ORIGINATION FORM

Proposed Revisions to a Standard Plans Index (Please provide all information – Incomplete forms will be returned)

Index Number: **522-001** Sheet Number (s): 1 and 2 of 2 Index Title: Concrete Sidewalk

LONGITUDINAL SECTION

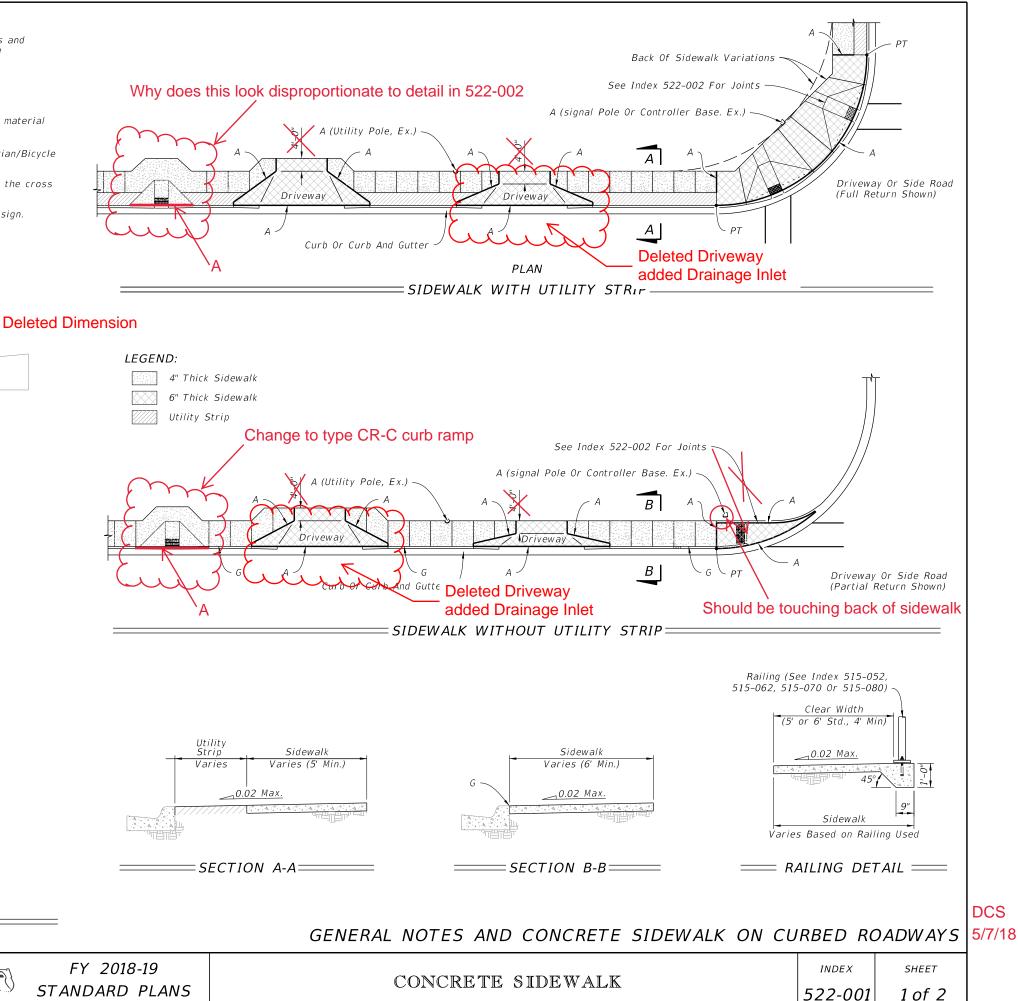
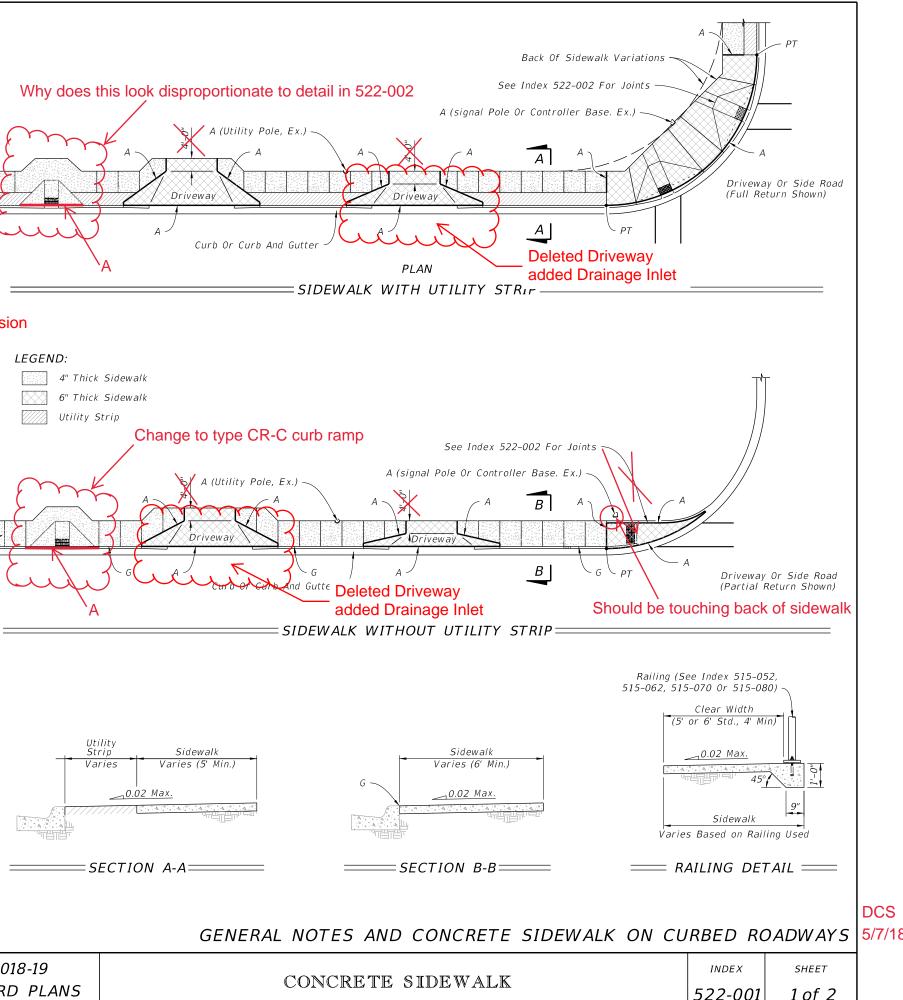
Sheet 1: Deleted the 6" Min. for turnouts or curb ramps call out and 8" dimension behind the Return Curbs in the LONGITUDINAL SECTION; Deleted 4'-0" dimension from driveways; changed curb ramp type in the SIDEWALK WITH UTILITY STRIP detail.

Deleted Dimension

LONGITUDINAL SECTION

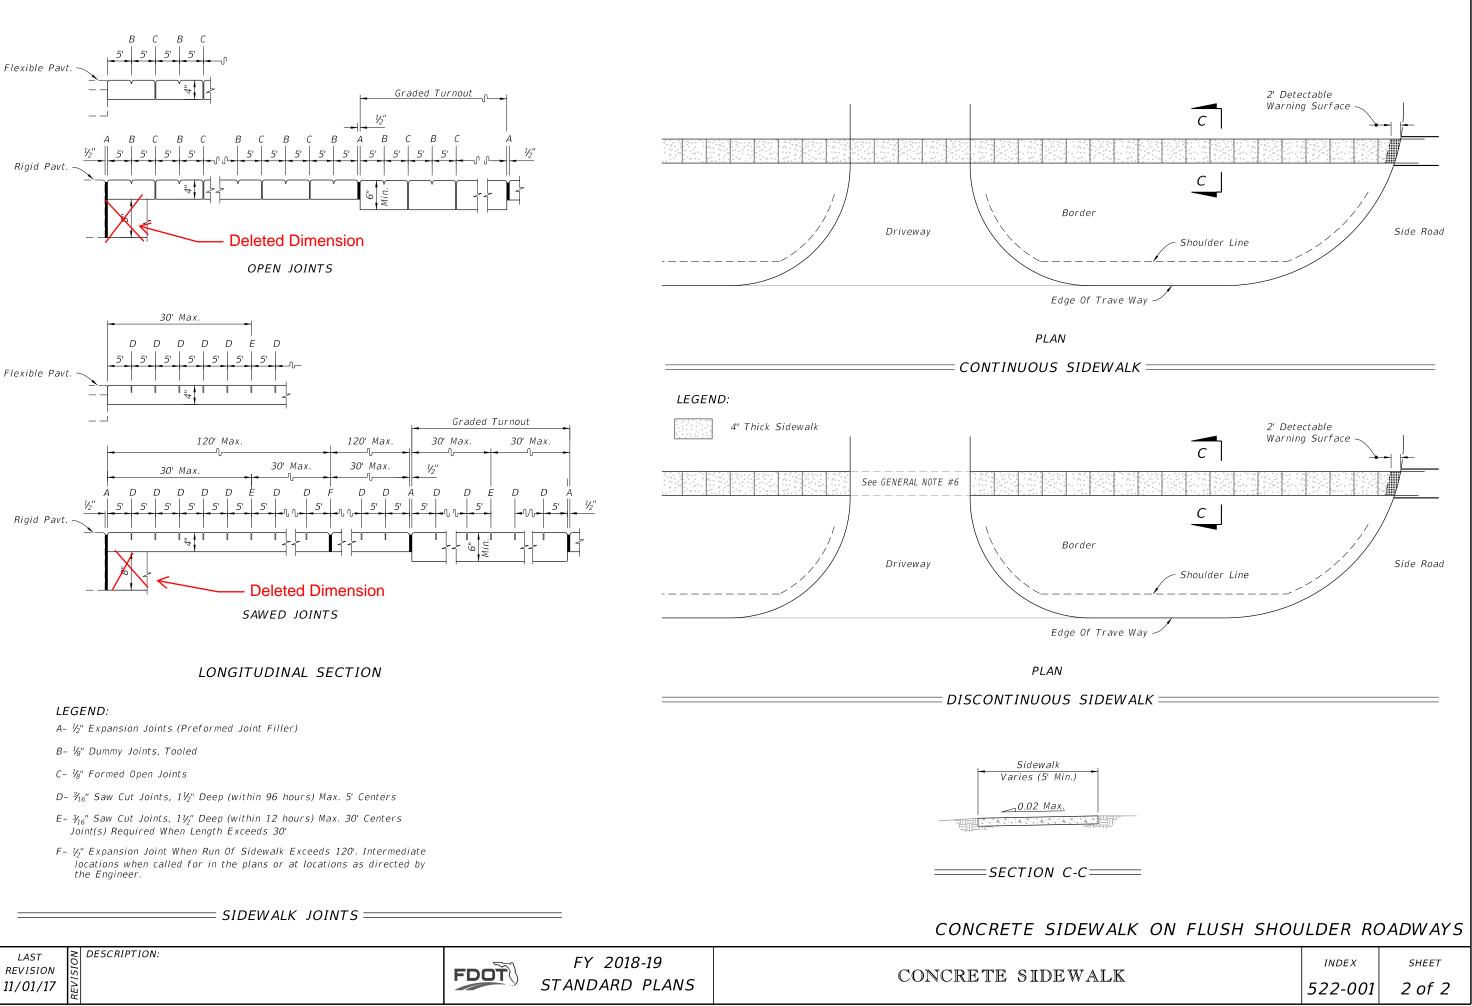
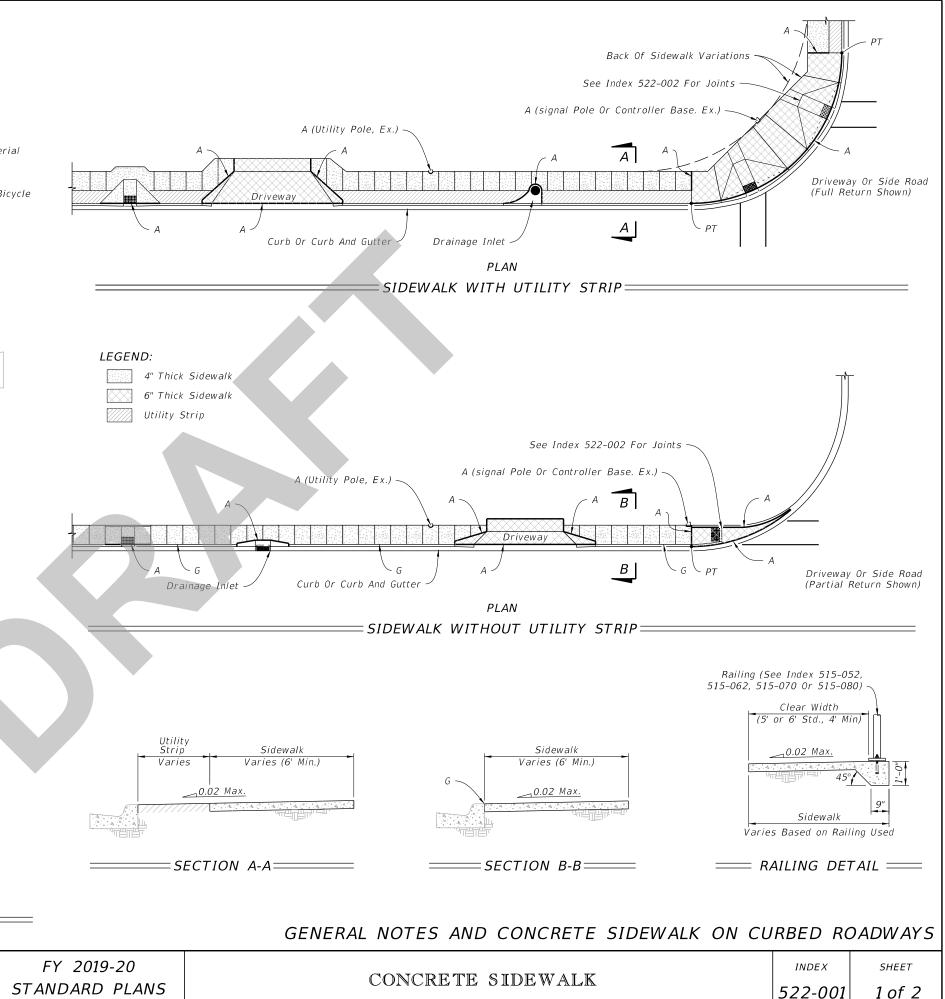
Sheet 2: Deleted 8" dimension behind the Return Curbs in the LONGITUDINAL SECTION:
